BOILER SAFETY REPORT

Rahimaaziz Knitspin Ltd

Factory ID: 9677

RSC RMG SUSTAINABILITY COUNCIL

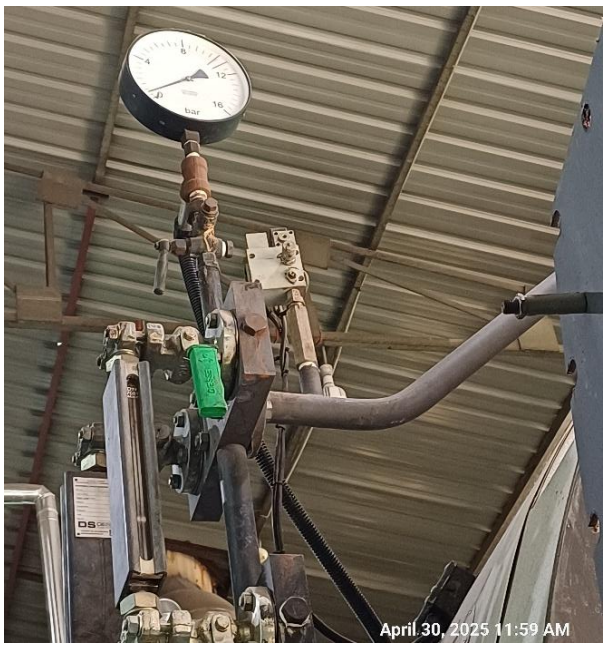
FINDING NO:	B-32
CATEGORY:	MONITORING AND CONTROL SYSTEM
BOILER REGISTRATION NO:	BB 13507
FINDING: The steam pressure gauge range was insufficient.	
RECOMMENDATION: The boiler pressure gauge range should be at least twice the boiler's maximum allowable working pressure mentioned in the boiler license or in accordance with any recognized international standard.	
PRIORITY:	P2
REMEDIATION TIME FRAME:	1 MONTH

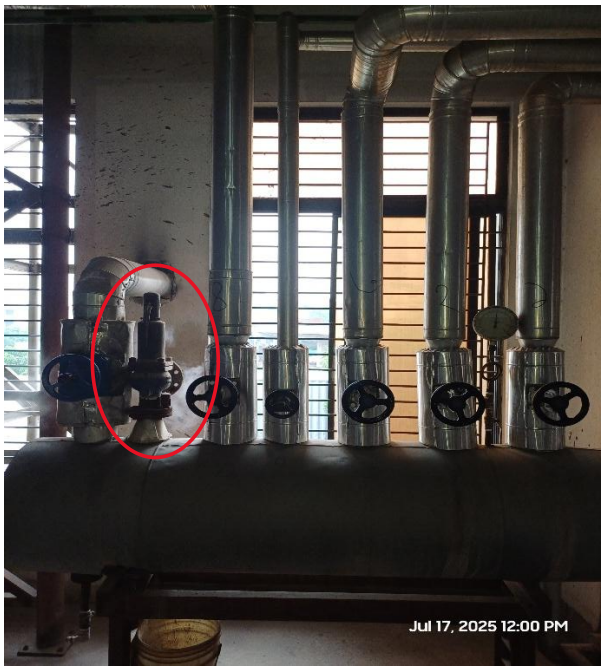
FINDING NO:	B-35
CATEGORY:	SAFETY VALVE
BOILER REGISTRATION NO:	BB 9022
FINDING: Boiler Steam Header Safety Valve outlet line was not directed outside of the boiler room.	
RECOMMENDATION: Boiler Steam Header Safety Valve outlet line should be directed outside of the boiler room with proper support and drainage system.	
PRIORITY:	P2
REMEDIATION TIME FRAME:	1 MONTH

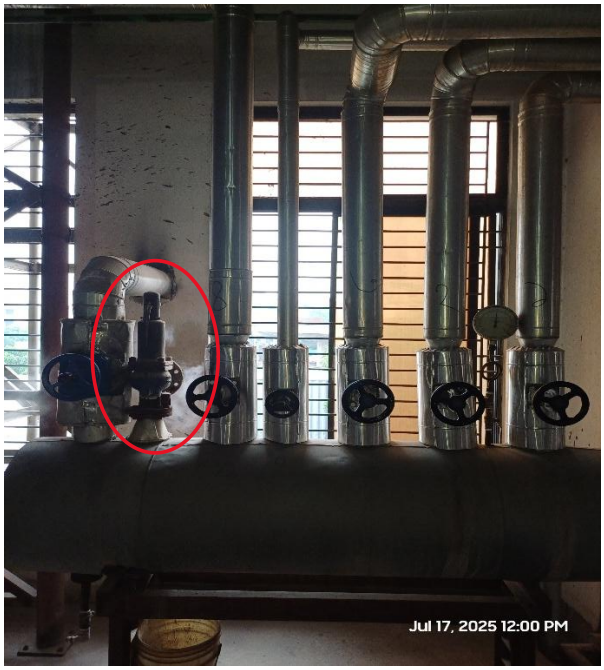
FINDING NO:	B-36
CATEGORY:	SAFETY VALVE
BOILER REGISTRATION NO:	BB 12459
FINDING: Boiler Steam Header Safety Valve outlet line was not directed outside of the boiler room.	
RECOMMENDATION: Boiler Steam Header Safety Valve outlet line should be directed outside of the boiler room with proper support and drainage system.	
PRIORITY:	P2
REMEDIATION TIME FRAME:	1 MONTH

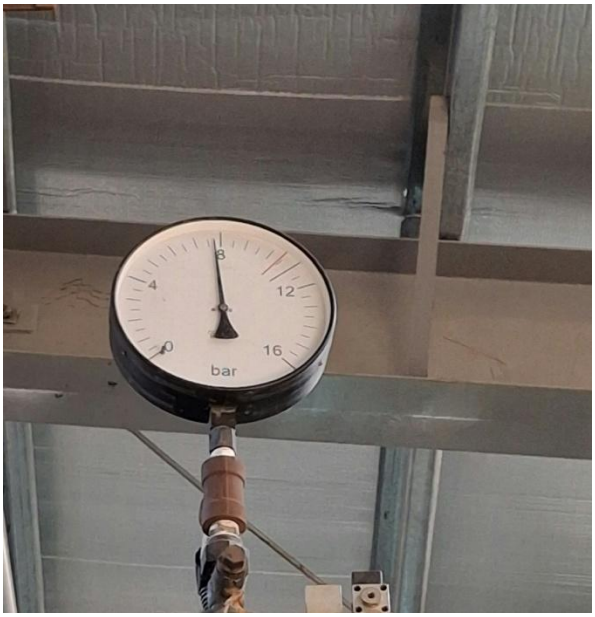
FINDING NO:	B-39
CATEGORY:	MONITORING AND CONTROL SYSTEM
BOILER REGISTRATION NO:	BB 13507
FINDING: Installed pressure gauge was inadequate in dial size and pressure rating according to manufacturing standard.	
RECOMMENDATION: Appropriate pressure gauge(s) shall be provided according to Bangladesh Boiler Regulation (BBR)/manufacturing standard/any standard recognized by the CIoB with consistent functionality.	
PRIORITY:	P3
REMEDIATION TIME FRAME:	2 MONTHS
